1. Project Name: Holiday Inn
2. Address of Subject Property: 16139 NW Hwy 441 Alachua, FL 32615
3. Parcel ID Number(s): 03053-001-001
4. Existing Use of Property: Vacant
5. Future Land Use Map Designation: Commercial
6. Zoning Designation: Commercial, Intensive (CI)
7. Acreage: 4.24 Acres

Re: Completeness Review Response – Holiday Inn Alachua Site Plan and Lot Split

Comments by: Adam Hall, Planner - Office of Planning and Community Development

BASIN DETAILS

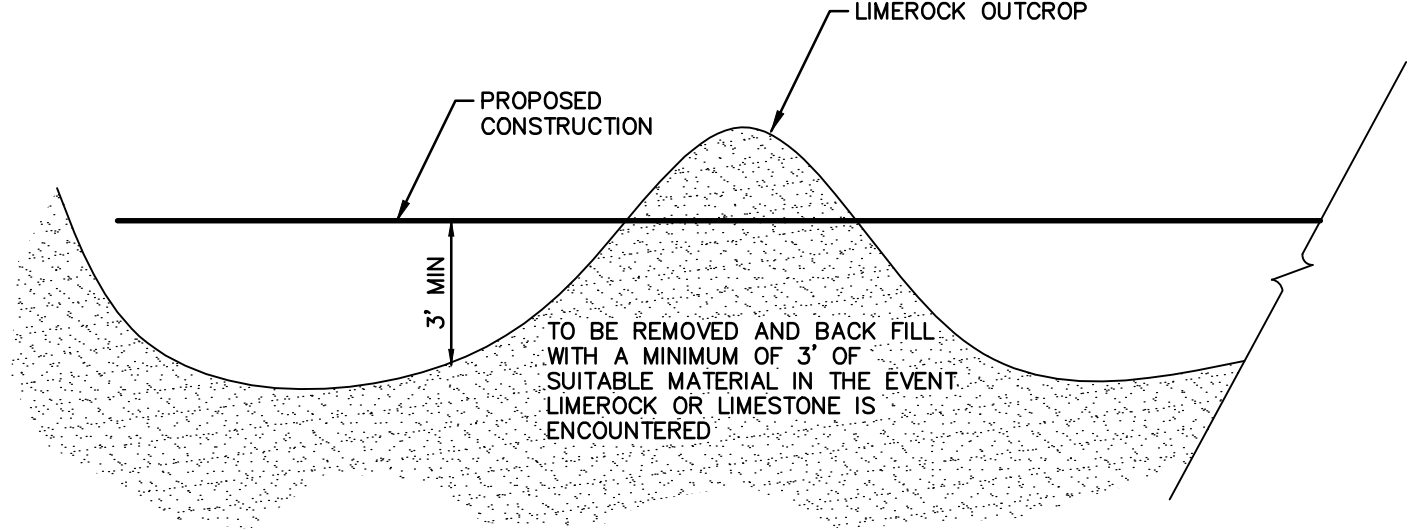
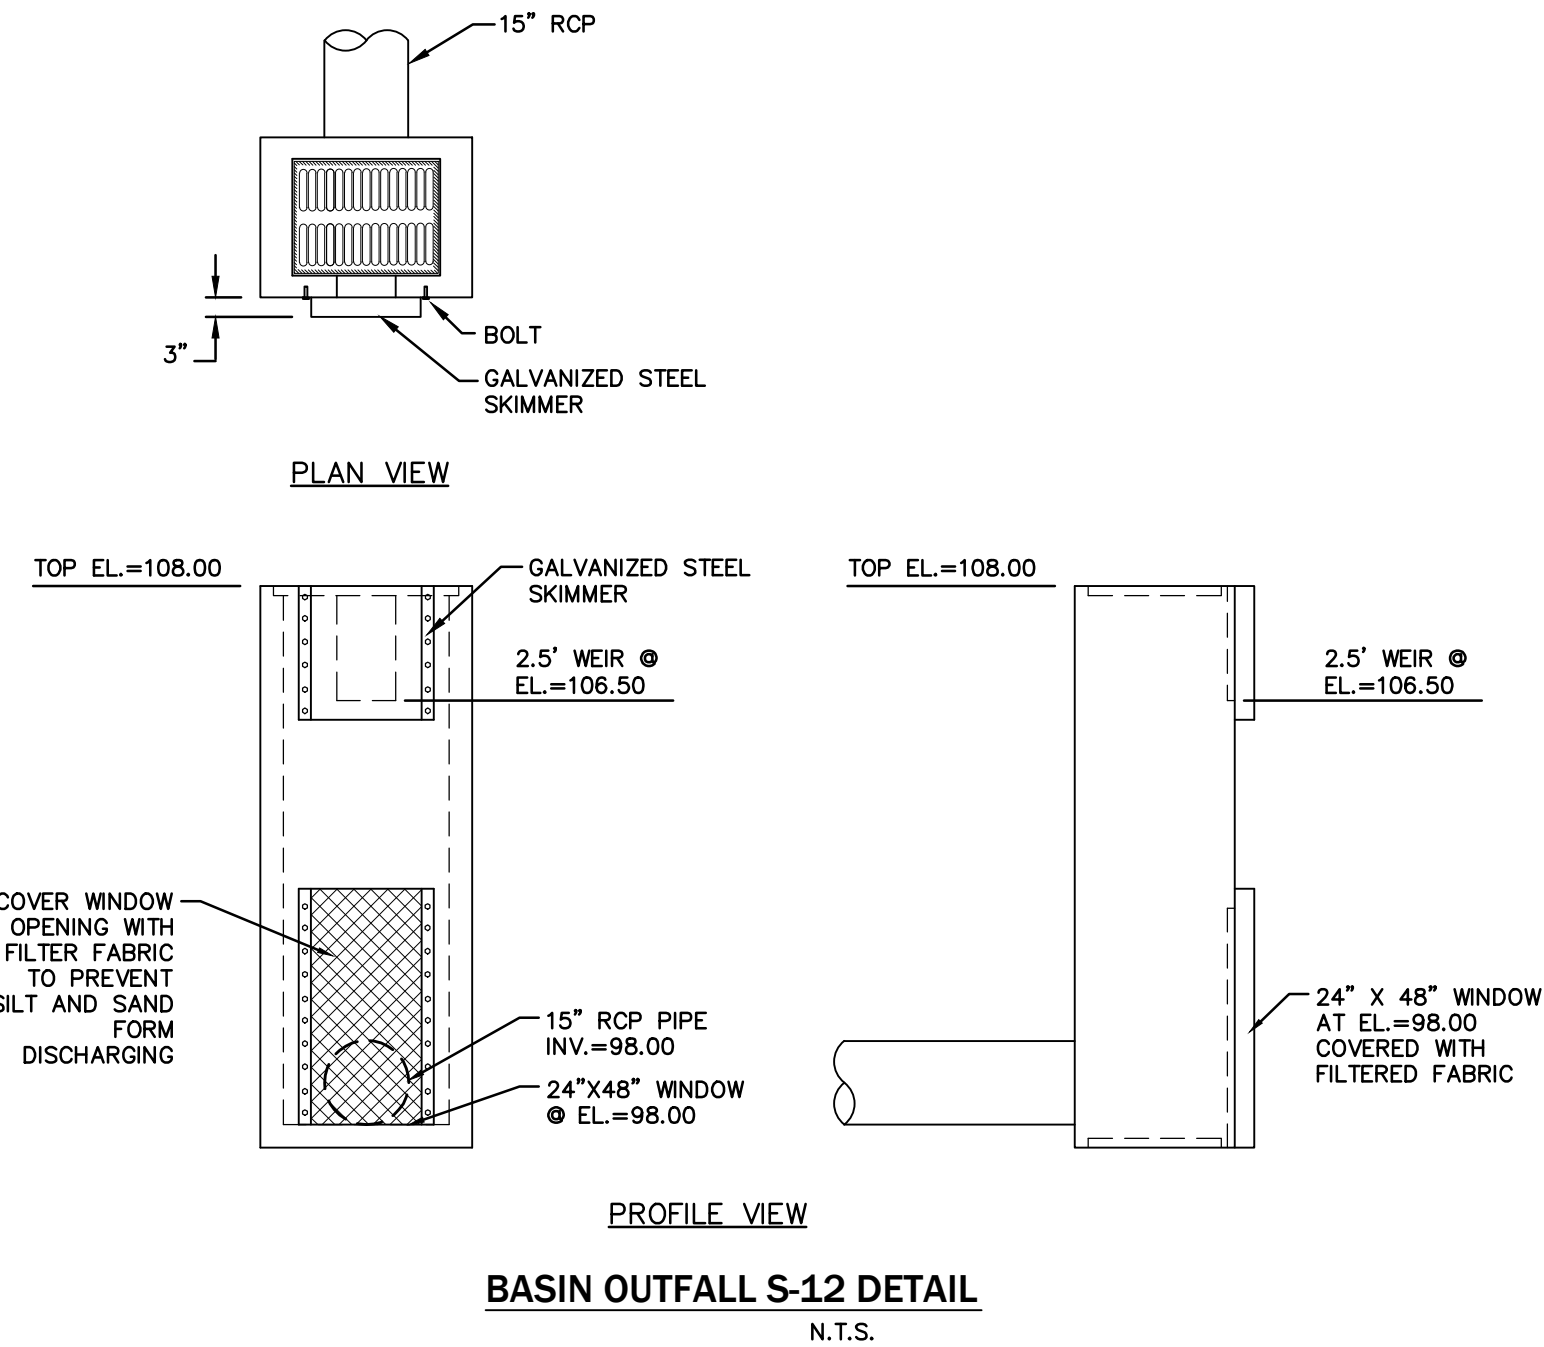
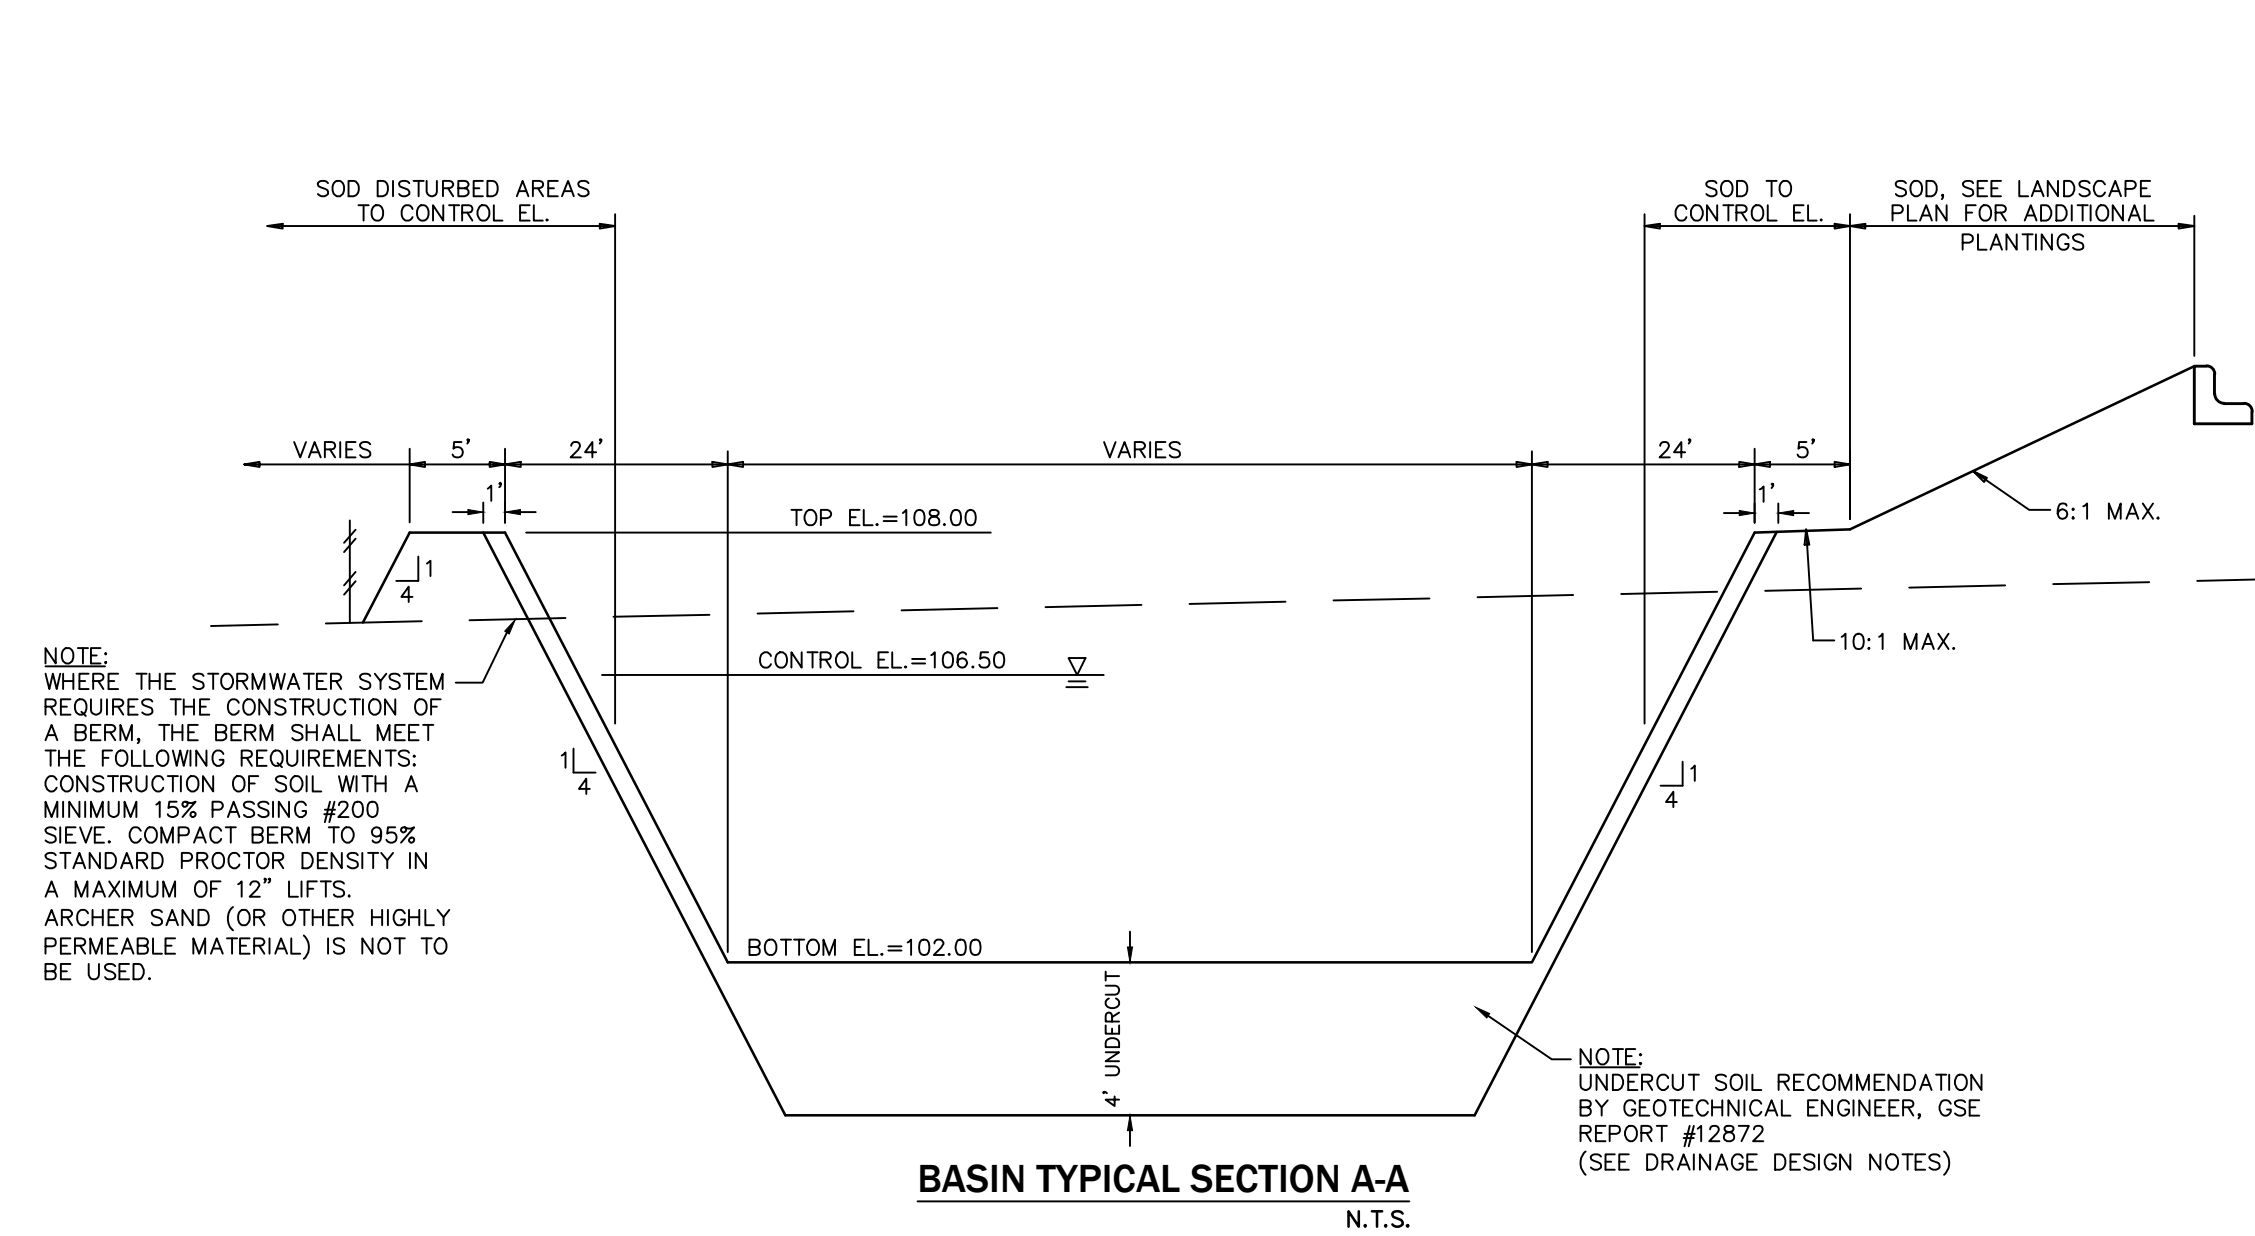
7. A note should be added in the basin plan view which identifies the location of the basin undercut limits per the GSE Geotechnical Report. These limits are to extend to the southeast of the basin to the elevation 98 contour and this is not depicted on the drawings. (Previous Comment)

8. Please clarify on the basin Section A-A if the undercut on the side slopes is 12" thick. (Previous Comment)

Response: See revised sheet C2.20.

Response: See revised sheet C2.20.
